2542 Garden Drive (COMPLETE APPLICATION)
DP-2019-00395 – CD-1 (pending)

DEVELOPMENT PERMIT STAFF COMMITTEE MEMBERS

DEVELOPMENT PERMIT STAFF COMMITTEE RECOMMENDATION: APPROVE

Figure 1: Shadow Study at Spring/Fall

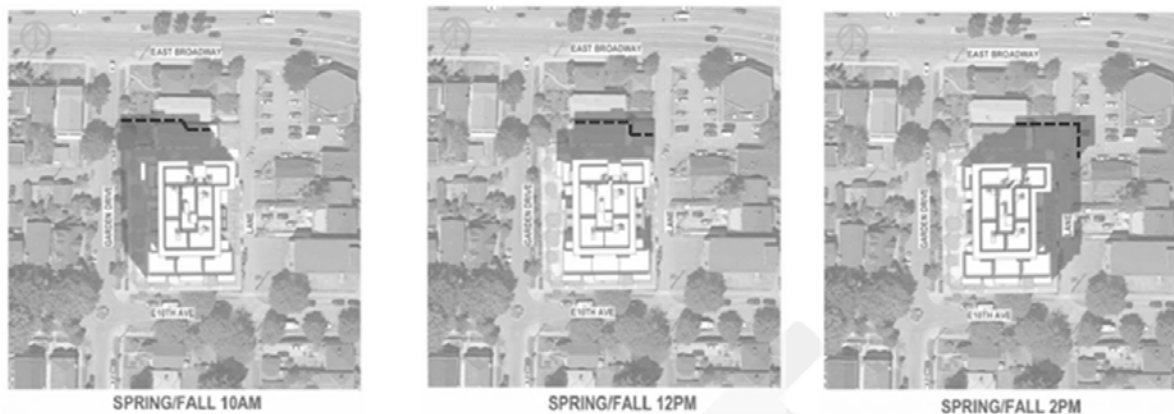
With a combination of the recommended setbacks, the extent of shadow can be mitigated, in particular the shadows onto the neighbour's rear yards and rear roof decks which require the most sun exposure. See Figure 1 which highlights the reduced shadows as a result of recommended reduced massing.

- i. setting back the 5th and 6th floor a minimum of 30 ft. from the rear property line and a minimum of 6 ft. from the north property line;

Figure 2: Garden Drive Streetscape

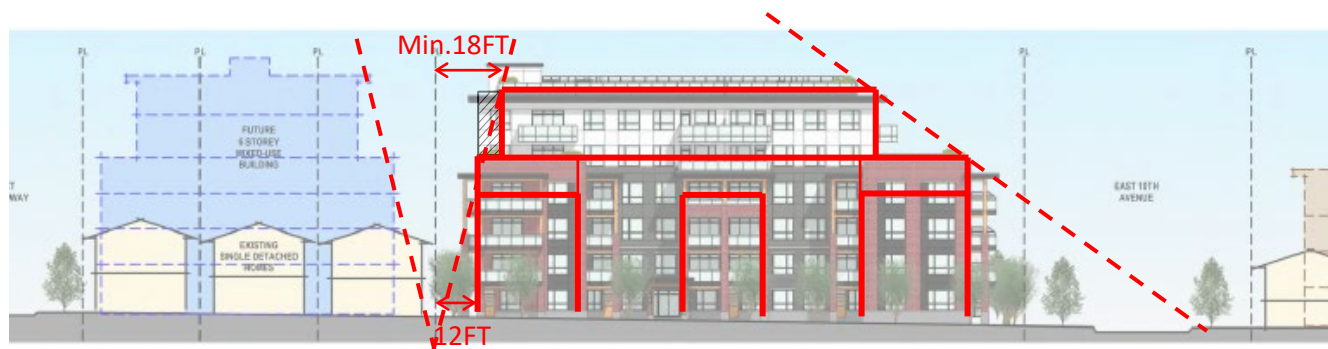
Figure 2 – the shaded area illustrates the recommended shoulder setback above the 4th floor from the north side that will significantly improve the access to daylight and openness to the sky.

Figure 3 illustrates the typical rear setbacks and shoulder setbacks for mid-rise development outlined in the Grandview Woodland Plan. The recommended rear setbacks on the 5th and 6th floors (Recommended condition 1.2) will reduce the massing and height at the northeast corner to achieve a more compatible form and scale at the lane and also enhance the anticipated development pattern in this area.

Figure 3 also illustrates that the frontage of the proposed building has provided deeper setbacks from Garden Drive which is featured with a landscaped forecourt and ground-oriented residential units. The recommended step backs above the 3rd floor shown as shaded area will enhance a better neighbourhood contextual fit to the existing neighbouring properties.
